University of South Carolina
Longstreet Theatre Shutter Replacement

State Project Number: H27-6100-F

February 20, 2015

ADDENDUM NO. 2

6 JAMB - J1
3" = 1'-0"

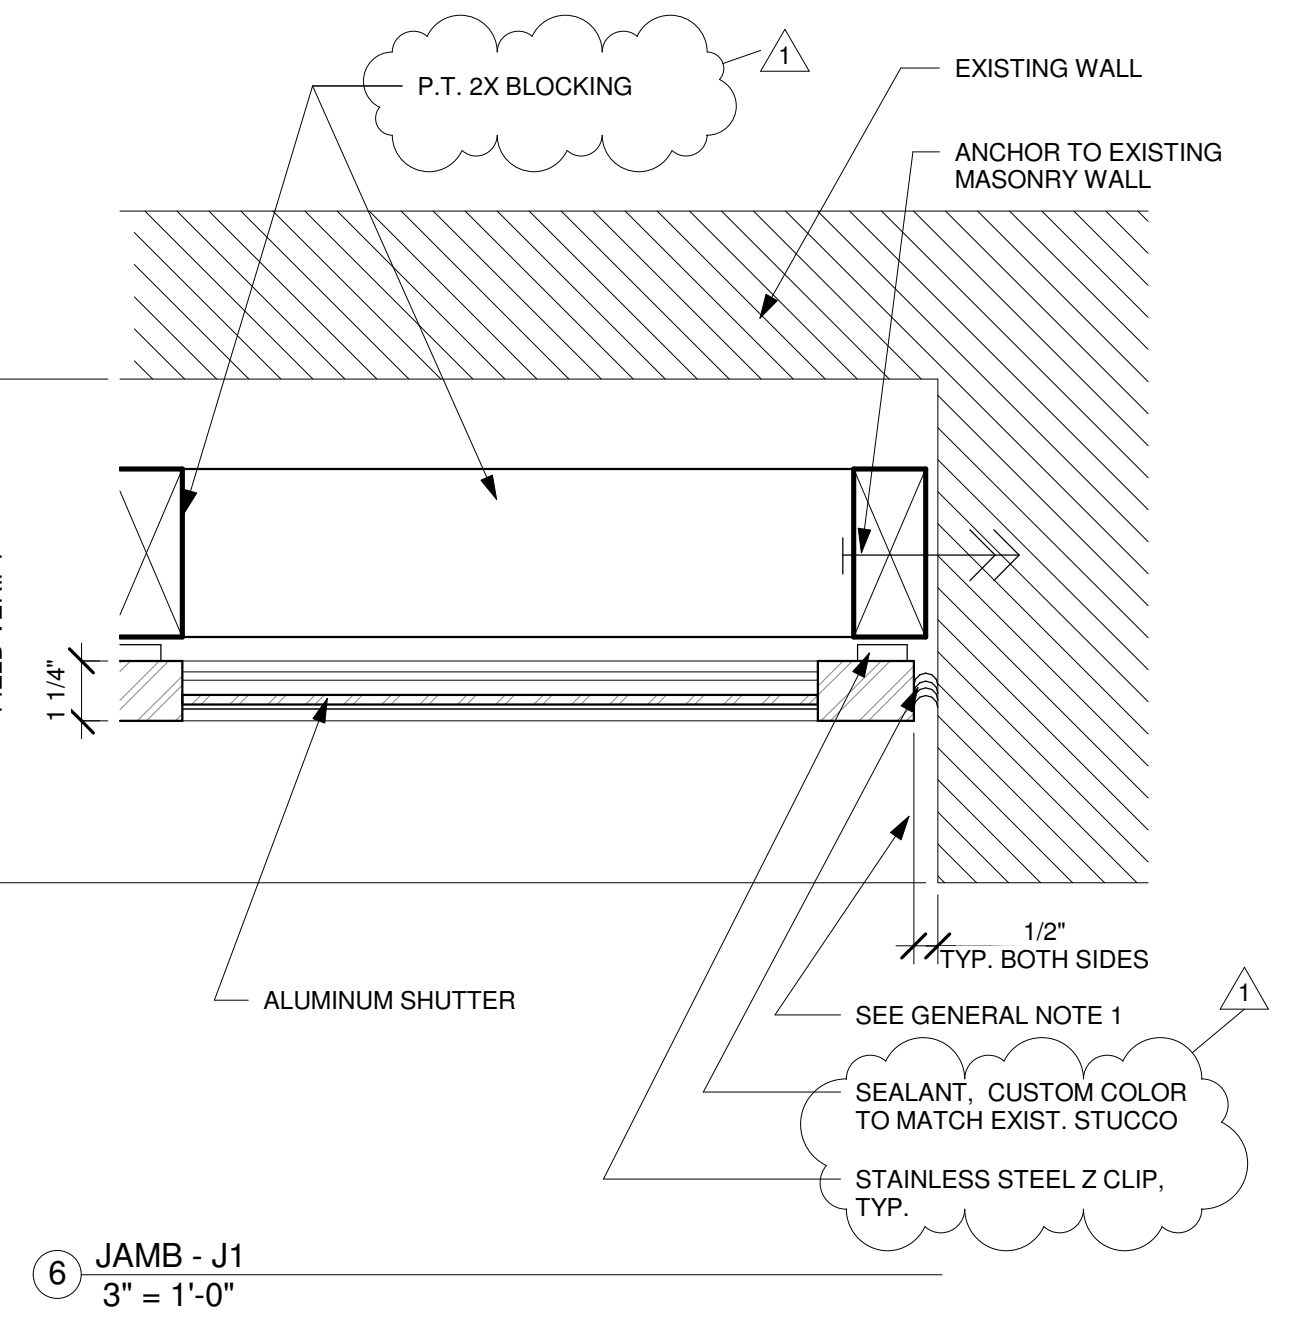
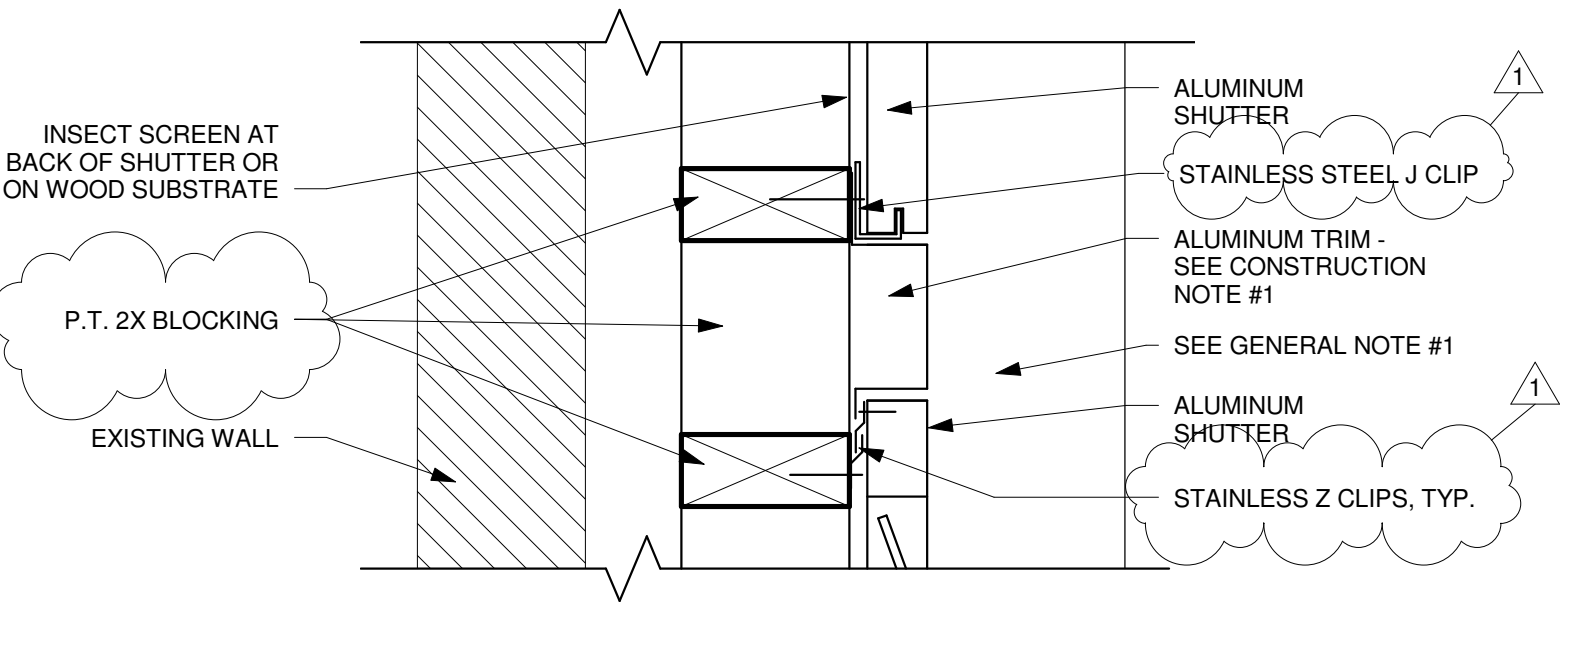
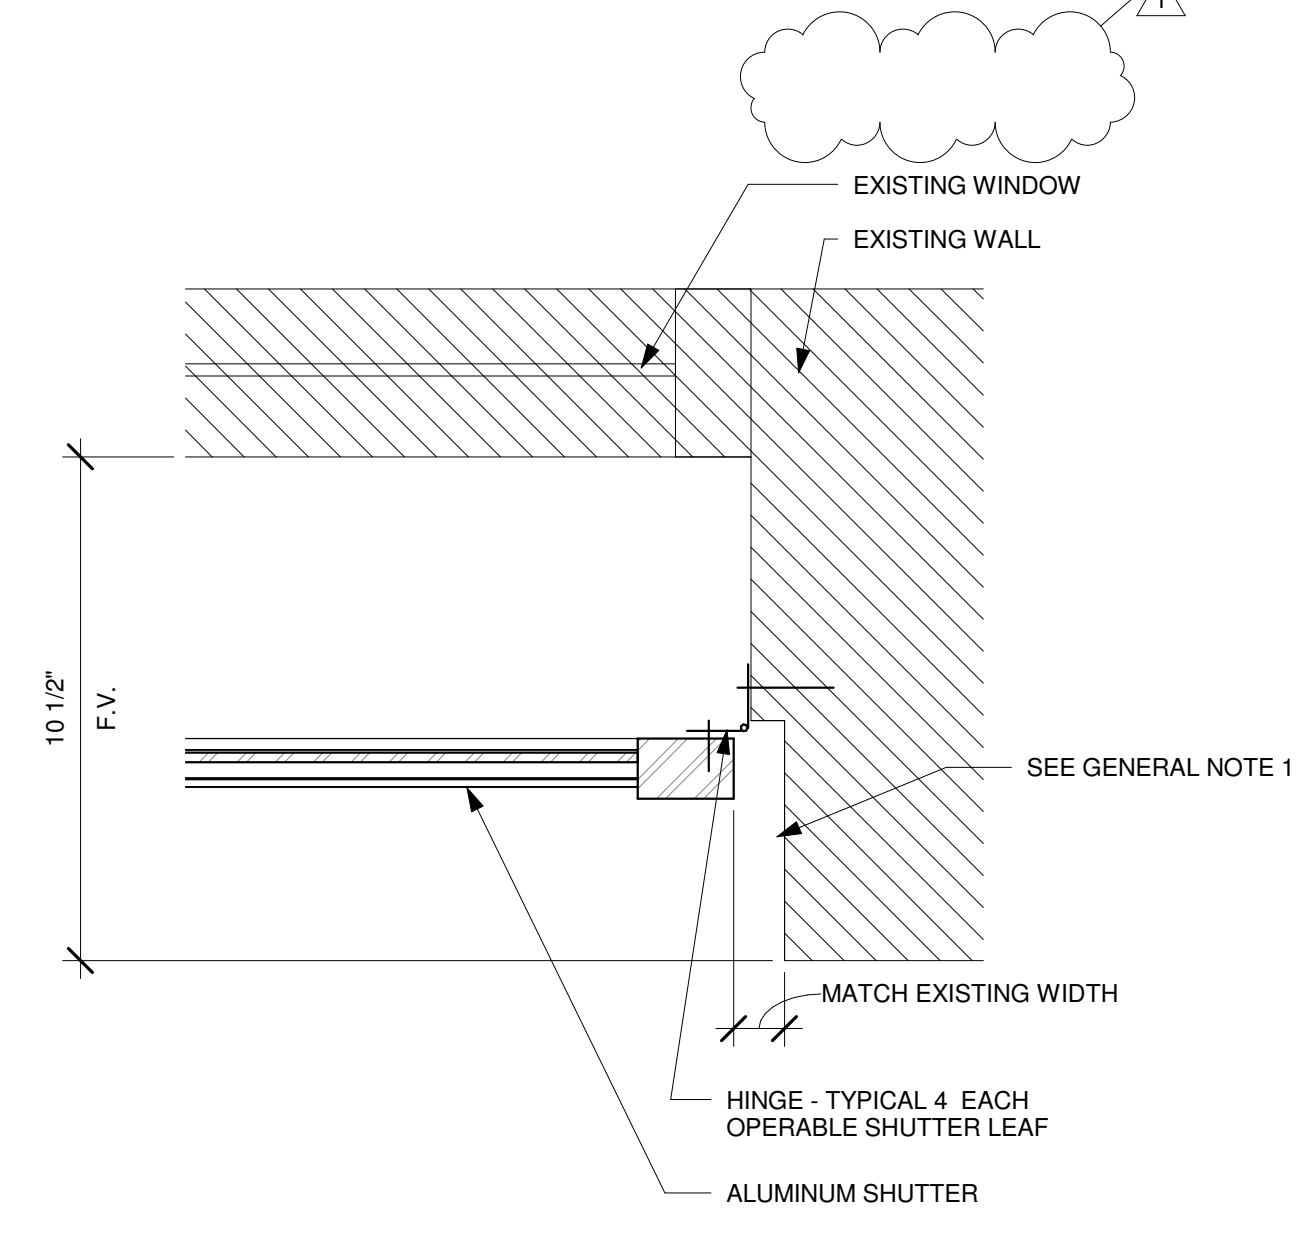
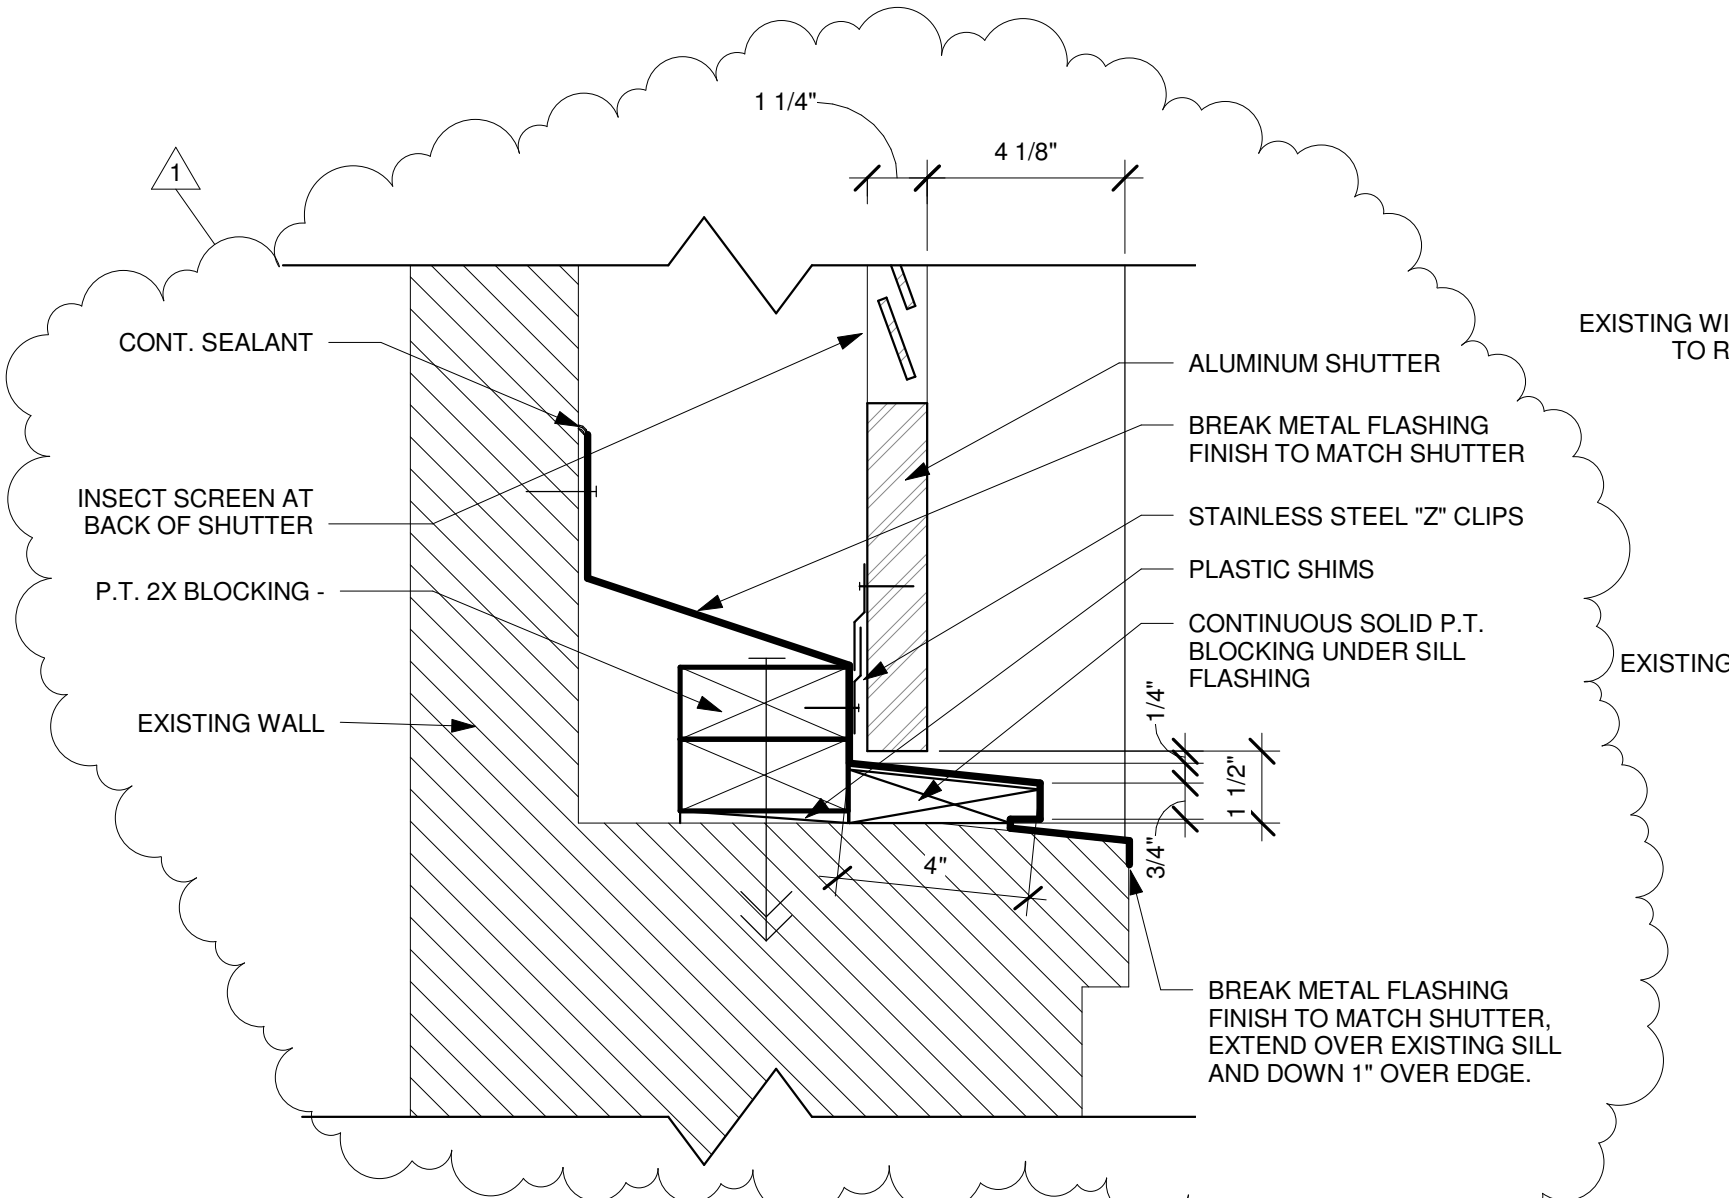
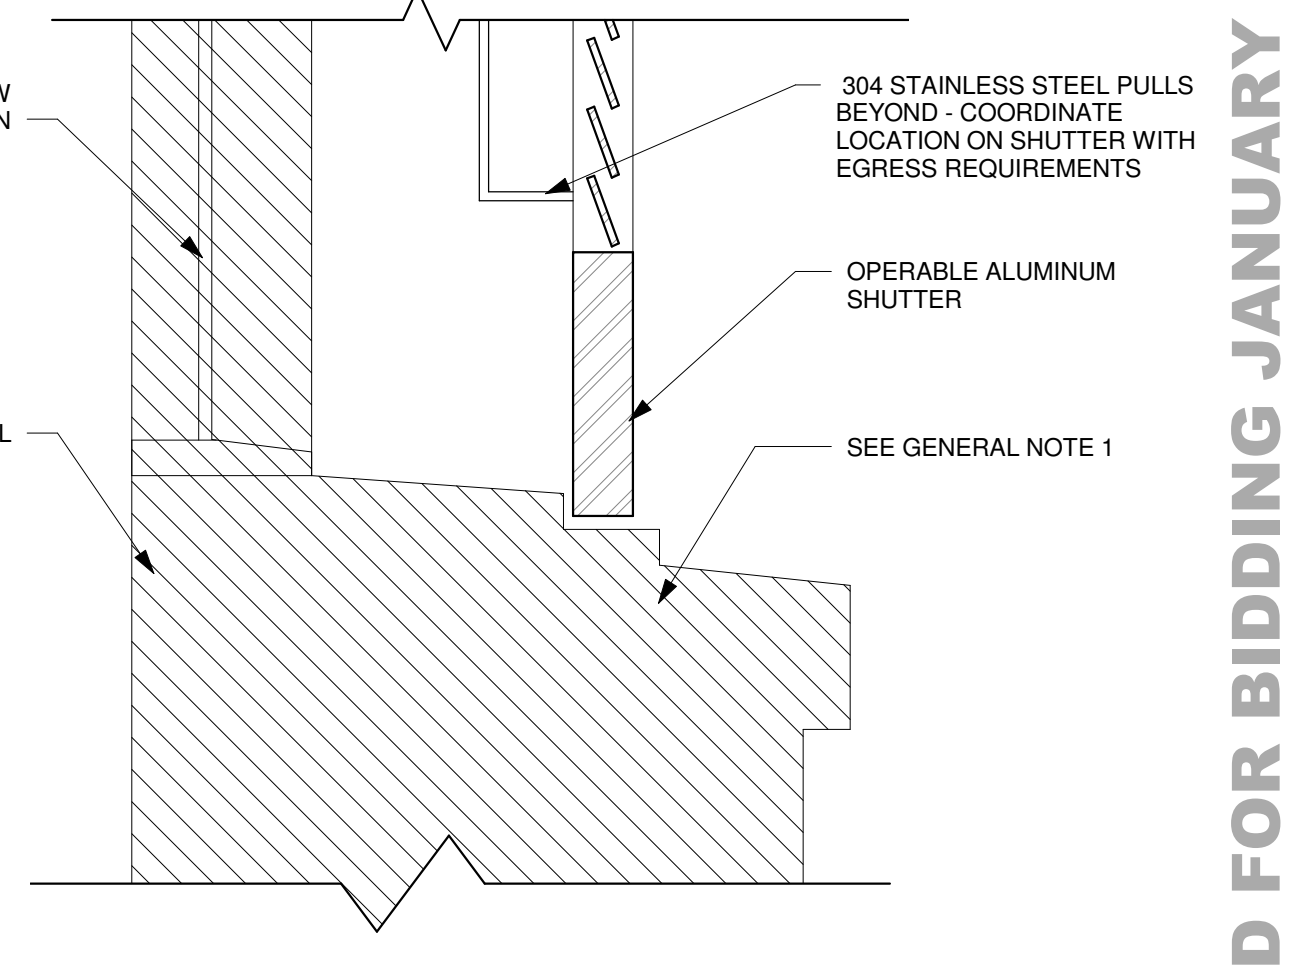
0. Question: Shutter 1,3,4 - 1.25 x 2 stile material is not an available size. Can 1.5 x 2 be substituted on stiles?
 1. **Answer: Yes**
1. Question: Shutter 1,3,4 - 1.25 x 3 rail material is not an available size. Can 1.5 x 3 be substituted?
 1. **Answer: Yes**
2. Question: Shutter 1,2,3,4 - 1.25 x 7.25 bottom rail is not an available size. Can 1.5 x 6 be substituted?
 1. **Answer: Yes**
3. Question: Shutter 2 - 1.25 x 5.5 mid rail is not an available size. Can 1.5 x 6 be substituted?
 1. **Answer: Yes**
4. Question: Shutter 2 - 1.25 x 3.25 stiles are not an available size. Can 1.5 x 3 be substituted?
 1. **Answer: Yes**

5. Question: Shutter 2 - 1.25 x 3.5 crown rail is not an available size. Can 1.5 x 3 be substituted?
1. Answer: Yes
6. Question: Shutter 2 - Can this be made as a three separate panels? Mating stiles could be 1.5 x 1.5 to yield 3" when ganged together.

1. Answer: Yes
7. Question: Drawings call for insect screen at back of shutter. Section 107113.13 EXTERIOR ALUMINUM SHUTTERS 2.3 Materials calls for a backing panel with the same finish as the shutter. Specify what the backing panel should be: solid or bug screen.

1. Answer: See changes to specification section 107113.13 in addendum 2.
8. Question: Please stipulate all joints that are to receive caulking/sealant.
1. Answer: Perimeter joints around the shutters are to receive sealant.
